Project	IEEE 802.16 Broadband Wireless Access Working Group < http://ieee802.org/16 >	
Title	Treatment by OBS on error report in IBS_IPBC procedure	
Date Submitted	2005-11-08	
Source(s)	Wu Xuyong Huawei Huawei Industrial Base, Bantian, Longgang, Shenzhen 518129 P.R.C	Voice: +86-755-28972214 Fax: +86-755-28972149 wuxuyong@huawei.com
Re:	80216h-05_023 : Call for Contributions: IEEE 802.16 License-Exempt Task Group 2005-10-17	
Abstract	To consolidate the procedure on dealing with the error report from the SSs that fail to receive the whole message of IBS_IPBC, the OBS can judge the interference source by comparing the frame number in the report message.	
Purpose	To consolidate the coexistence neighbor discovery procedure	
Notice	This document has been prepared to assist IEEE 802.16. It is offered as a basis for discussion and is not binding on the contributing individual(s) or organization(s). The material in this document is subject to change in form and content after further study. The contributor(s) reserve(s) the right to add, amend or withdraw material contained herein.

Treatment by OBS on error report in IBS_IPBC procedure

Wu Xuyong, Zhao Quanbo,
Huawei

figure h10: CTS usage example- IBS broadcasting IP address to coexistence neighbor's SS

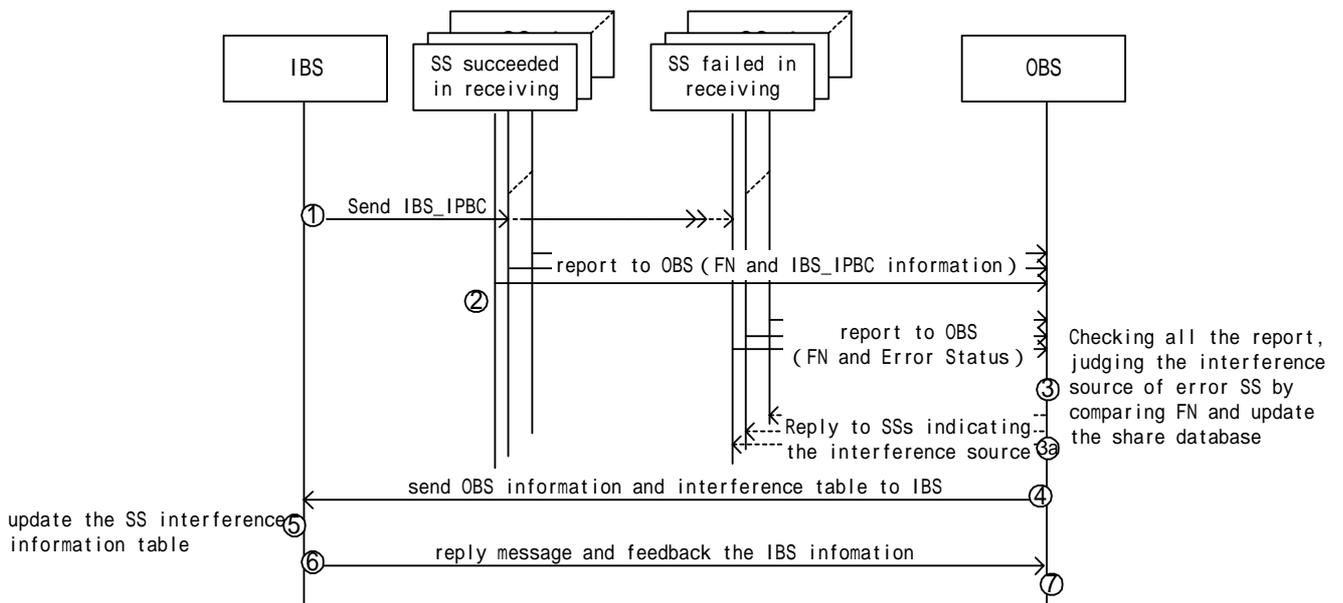
[change the figureh10 to the following]
